To:	Karyn Lewis, Project Manager Lupin Project Mandalay Resources Corporation, Suite 330, 76 Richmond Street Toronto, ON M5C 1P1	From:	Alvin Tong Stantec Consulting Ltd., 1100 – 111 Dunsmuir Street Vancouver, BC V6B 6A3
File:	Lupin Gold Project - 129500081	Date:	November 14, 2019

Reference: 2 AM-LUP Technical Meeting Commitment Number 6 Response – Geotechnical Review on the Long-Term Stability of TCA Dams

This memorandum presents the design basis, stability analyses results, and recommendations to satisfy long term stability and erosion control for all the dams at Lupin.

TAILINGS CONTAINMENT AREA
CELL 3 COVER AND SURFACE
WATER MANAGEMENT

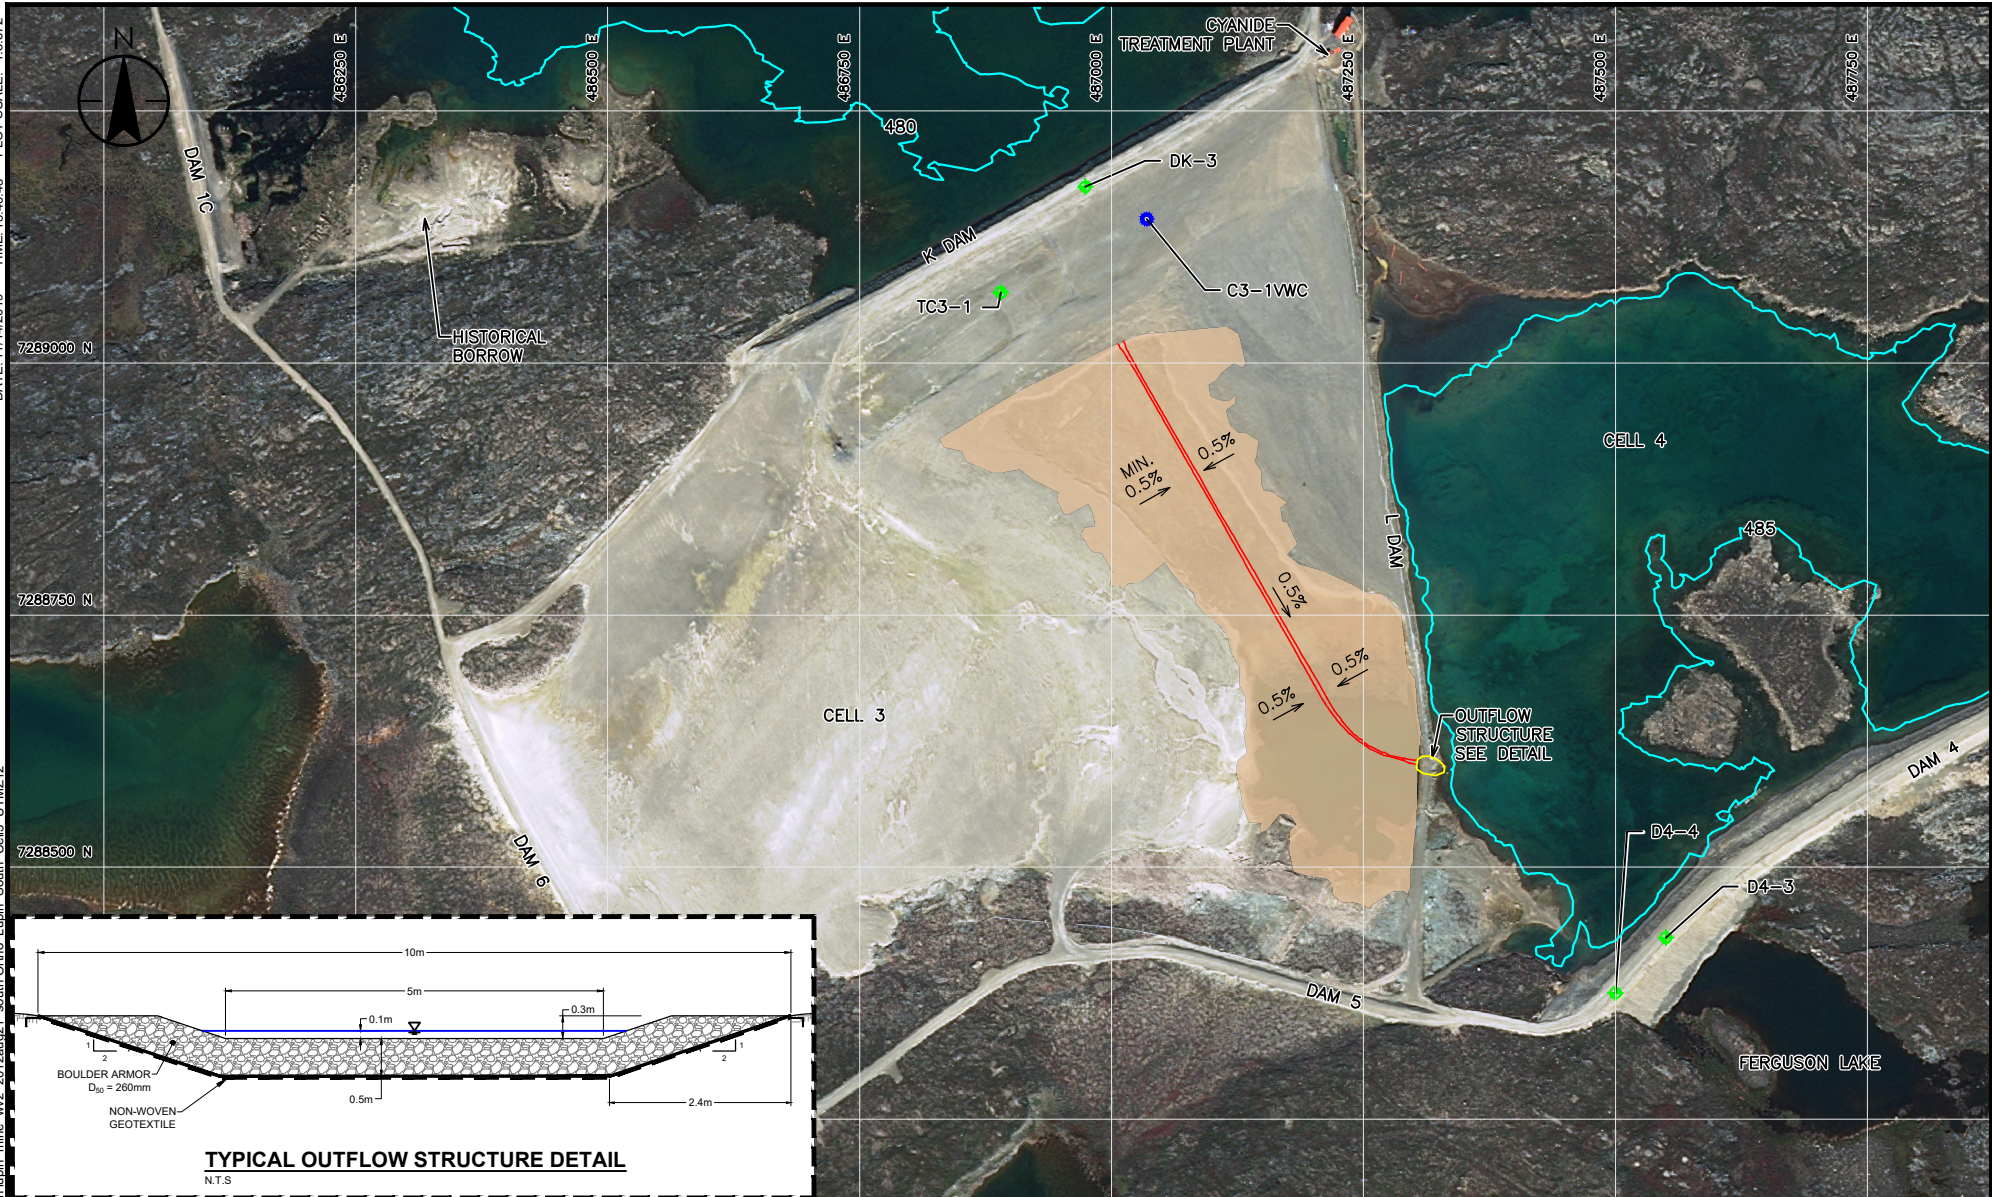
As part of the final closure and reclamation plan (FCRP), surface water management will be incorporated into the Cell 3 and 5 tailings cover to manage long term erosion potential. It is recognized that the existing topographies of the Cell 3 and 5 covers would have surface water flow over the dams that could cause erosion. The FCRP would incorporate surface water management into the to-be-constructed cover to minimize potential erosion of the dams. The to-be constructed tailings covers will be engineered and contoured to allow surface water to flow passively away from the face of the dam and into an engineered outflow structure. Both Cell 1 and 2 do not have significant gradient toward the dams and additional cover regrading is not required based on current information available. The design criteria for the surface water management on the covers are shown in Table 4.

The Cell 3 engineered cover design is shown on Figure 2 and Cell 5 engineered cover design is shown on Figure 3. These should mitigate long term erosion potential over the dam face.

Parameter	Value
Design Event	1 in 100-year
Design maximum flow	0.8 m ³ /s
Design maximum velocity	1.9 m/s
Cover maximum grade	0.5%
Outflow channel side slopes	Min. 3H:1V
Outflow channel bottom	5m
Outflow channel maximum grade	10%
Outflow channel armoring size	D ₅₀ = 0.26m

SLOPE STABILITY ANALYSIS
SECTION K – PERMAFROST CONDITIONS
STATIC CASE – LOCAL FAILURE

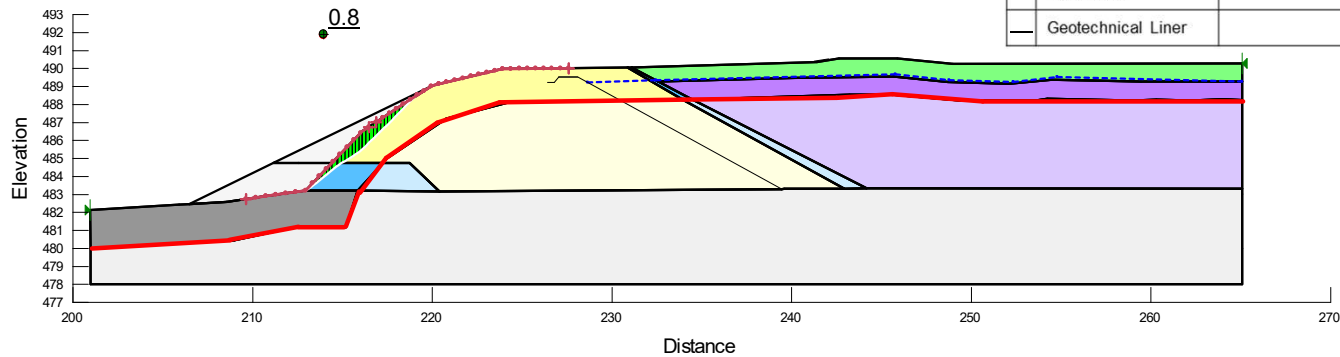
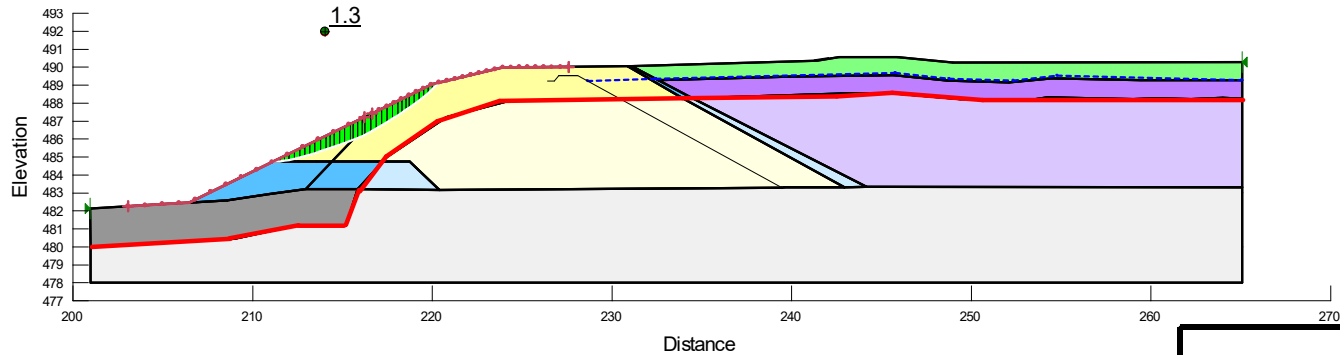
*FOS value does not meet design criteria for as-built configuration, repair and re-sloping is required for closure.

Results in Table 3 show that the existing as-built dams meet the target FOS criteria except for dams M and K. Modifications to these dams are required and details are discussed below.

- Dam M: re-slope to 2.1H:1V;
- Dam K: re-slope to 2.1H:1V

Details:**Current Permafrost Conditions:** permafrost is present at depth 2m below ground surface**Re-sloped Conditions:** reggraded to 2H:1V to reach minimum FOS criteria
